UNITED STATES PATENT AND TRADEMARK OFFICE

APPLICATION NO.	FILING DATE	FIRST NAMED INVENTOR	ATTORNEY DOCKET NO.	CONFIRMATION NO.
10/707,006	11/13/2003	Abdelaziz Ikhlef	GEMS 0215 PA	1005
27256	7590	03/30/2006	EXAMINER	
ARTZ & ARTZ, P.C. 28333 TELEGRAPH RD. SUITE 250 SOUTHFIELD, MI 48034			HO, ALLEN C	
			ART UNIT	PAPER NUMBER
			2882

Office Action Summary	Application No.	Applicant(s)	
	10/707,006	IKHLEF, ABDELAZIZ	
	Examiner	Art Unit	
	Allen C. Ho	2882

DETAILED ACTION

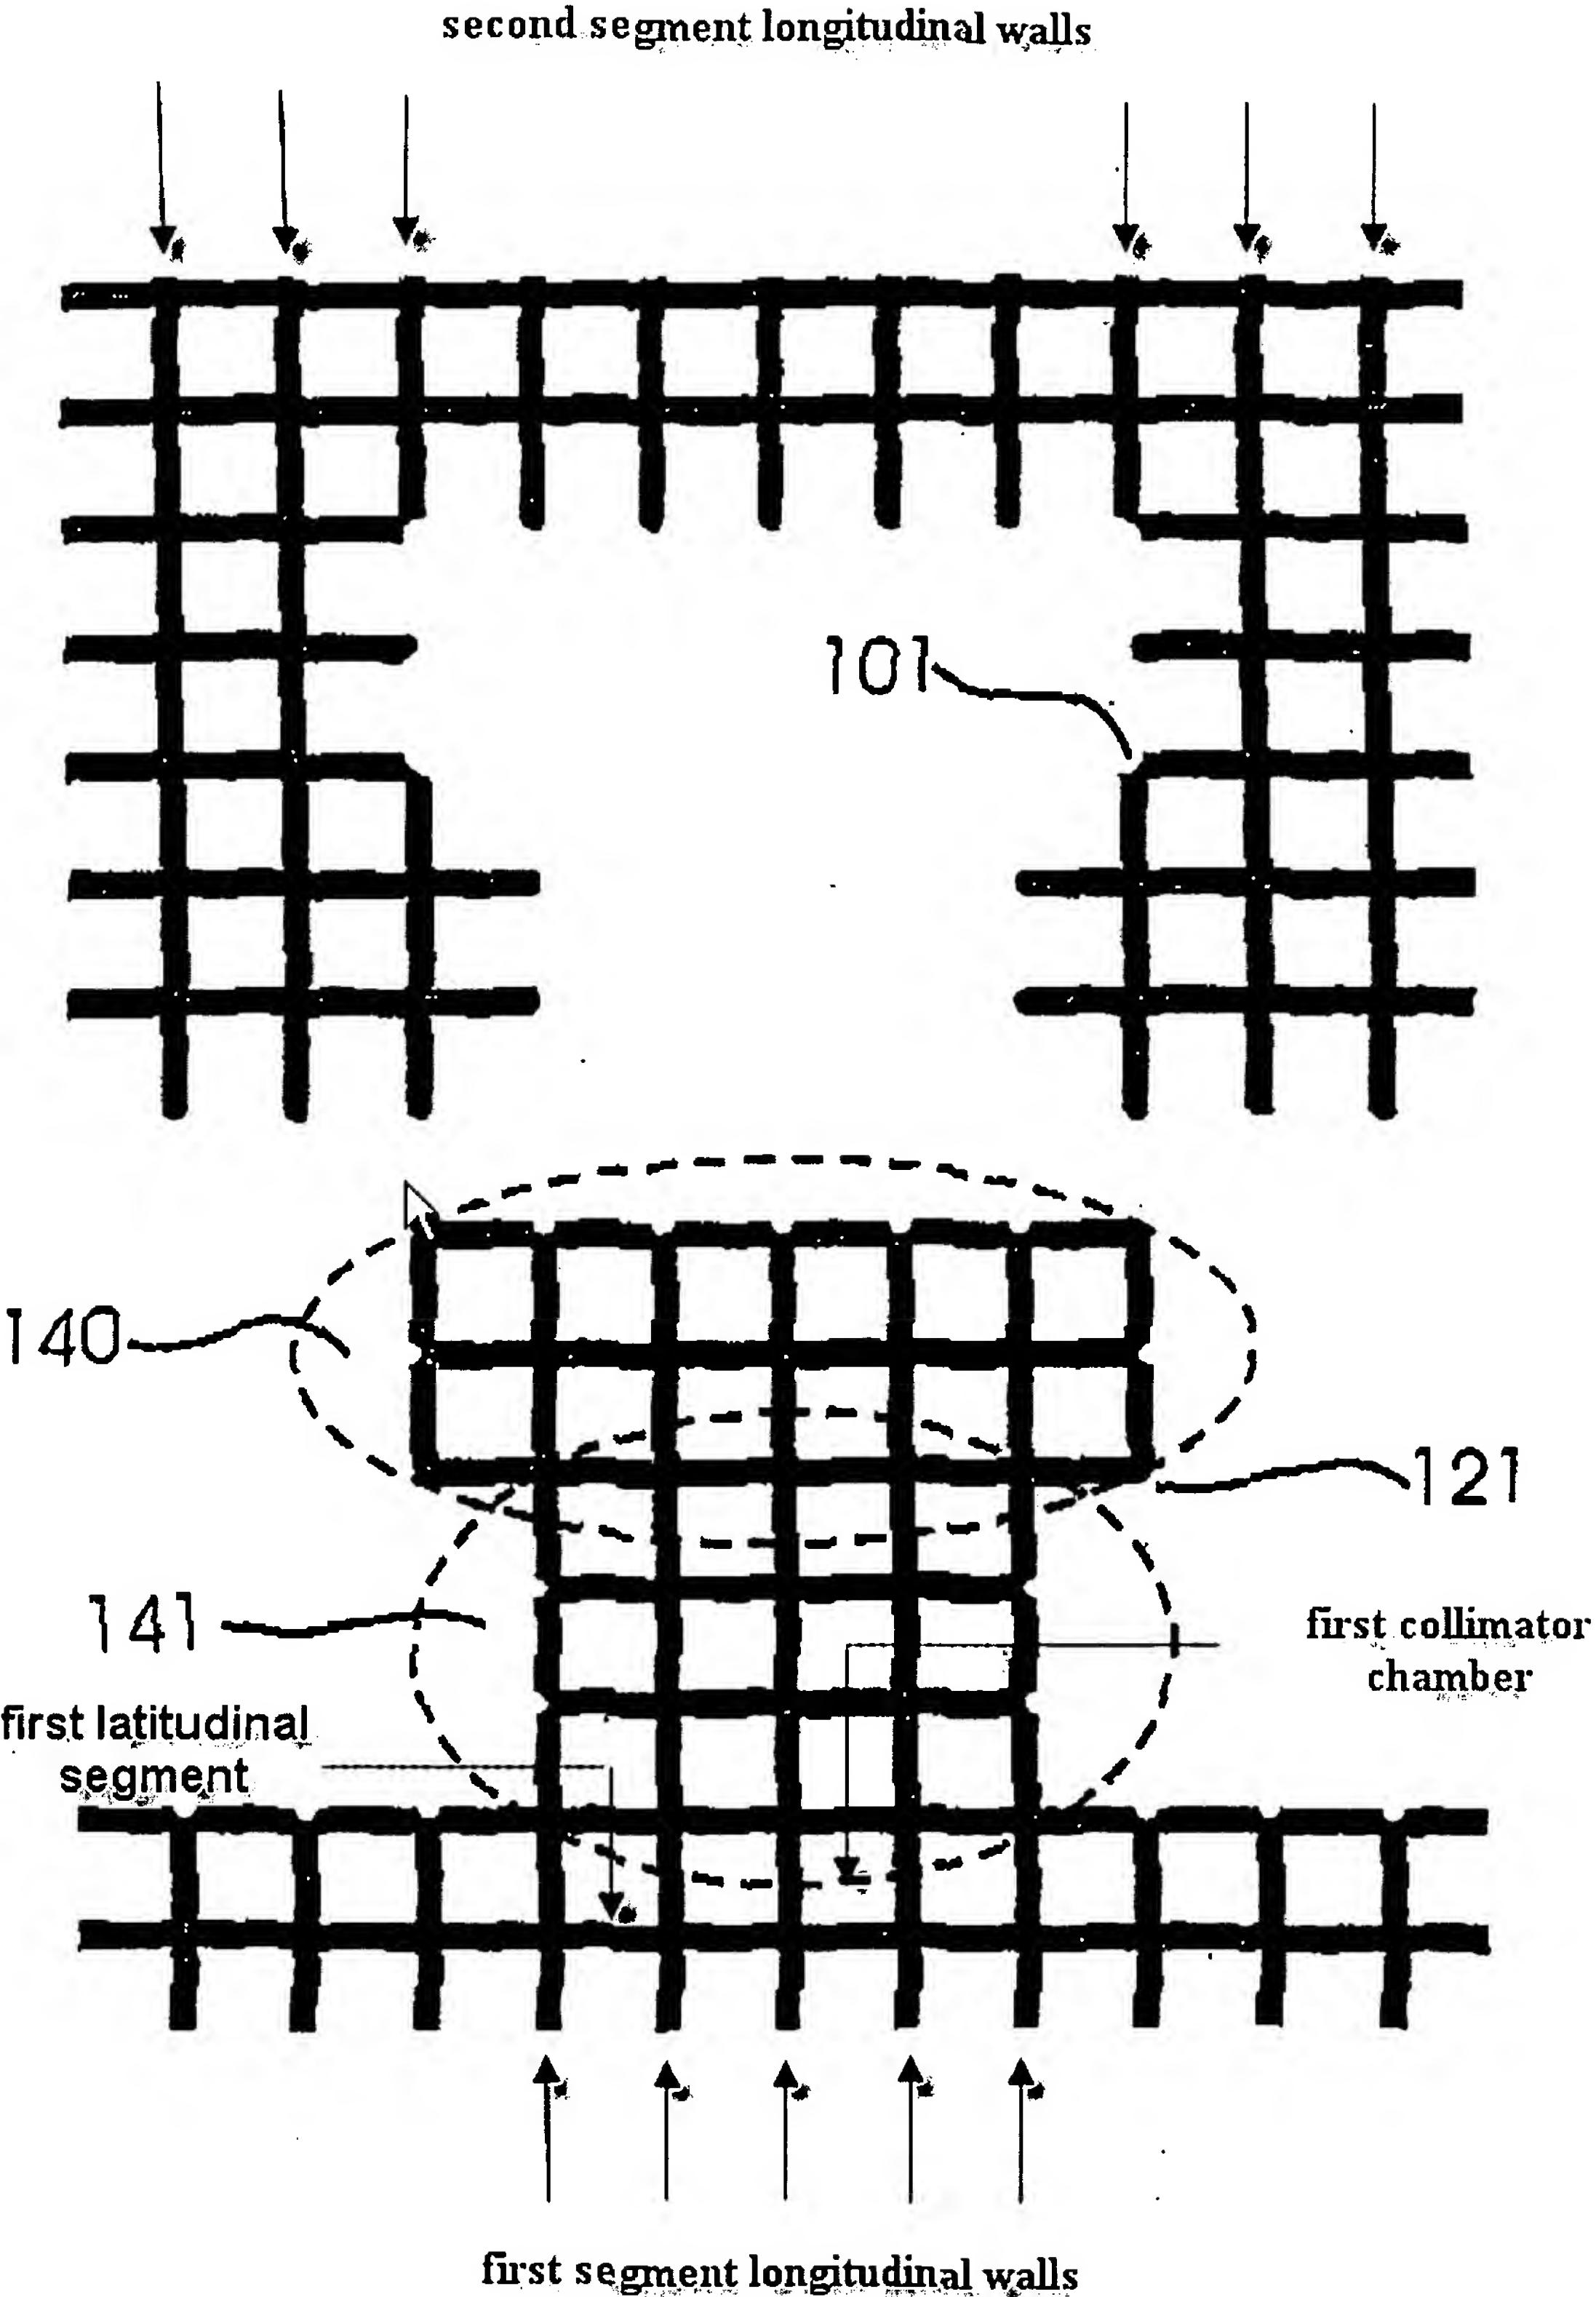
With regard to claim 1, Tang disclosed a detector assembly comprising: a collimator assembly (30) comprising:

a first collimator segment (120) having a first left end and a first right end, the first collimator segment comprising: a plurality of first segment longitudinal walls having a first segment depth, each of the plurality of first segment longitudinal walls including a first locking protrusion (140, 141) comprising only a portion (the entire portion) of the first segment depth, the plurality of first segment longitudinal walls configured to be planar to projected x-rays; and

a second collimator segment (100) having a second left end and a second right end, the second collimator segment comprising: a plurality of second segment longitudinal walls having a second segment depth, each of the plurality of second segment longitudinal walls including a second interlocking protrusion (103) comprising only a portion (the entire portion) of the second

segment depth, each of the second interlocking protrusion engaging one of the first interlocking protrusions to form a continuous side wall segment; and

a plurality of first latitudinal segments positioned between each of the plurality of first longitudinal walls such that a plurality of first collimator chambers is formed, each of the first collimator chambers having a first collimator width (Fig. 4).

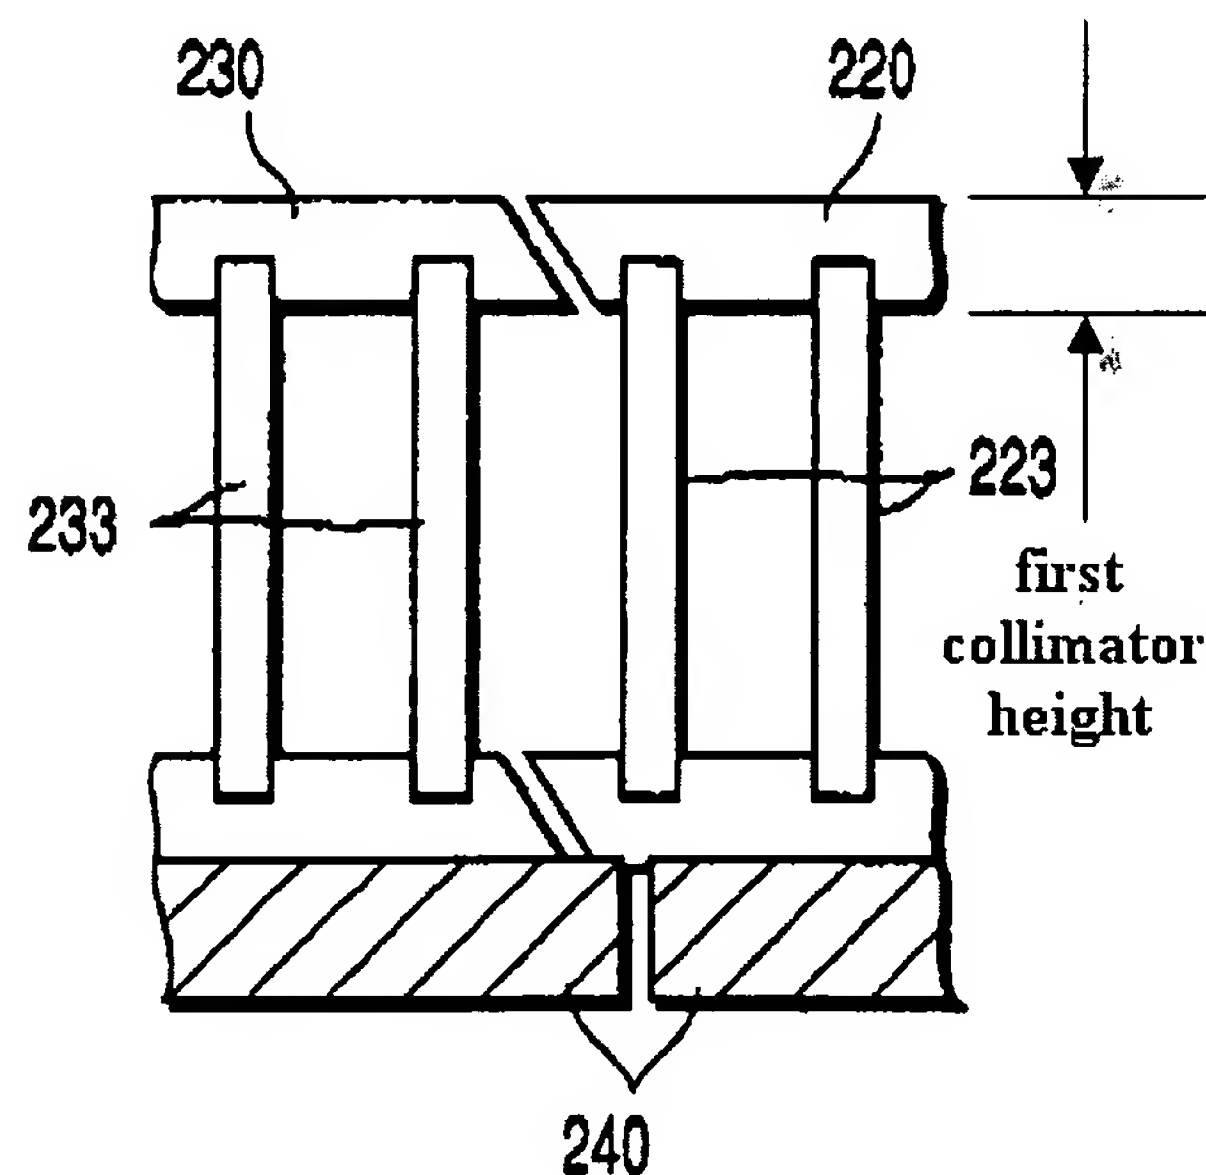
With regard to claim 1, Igarashi *et al.* disclosed a detector assembly comprising: a collimator assembly (Figs. 10A, 10B, 10C) comprising:

a first collimator segment (220) having a first left end and a first right end, the first collimator segment comprising: a plurality of first segment longitudinal walls (221, 222) having a first segment depth, each of the plurality of first segment longitudinal walls including a first locking protrusion (tapered shape) comprising only a portion (the entire portion) of the first segment depth; and

a second collimator segment (230) having a second left end and a second right end, the second collimator segment comprising: a plurality of second segment longitudinal walls (231, 232) having a second segment depth, each of the plurality of second segment longitudinal walls including a second interlocking protrusion (tapered shape) comprising only a portion (the entire portion) of the second segment depth, each of the second interlocking protrusion engaging one of the first interlocking protrusions to form a continuous side wall segment; and

a plurality of first latitudinal segments (223) positioned between each of the plurality of first longitudinal walls such that a plurality of first collimator chambers is formed, each of the first collimator chambers having a first collimator width.
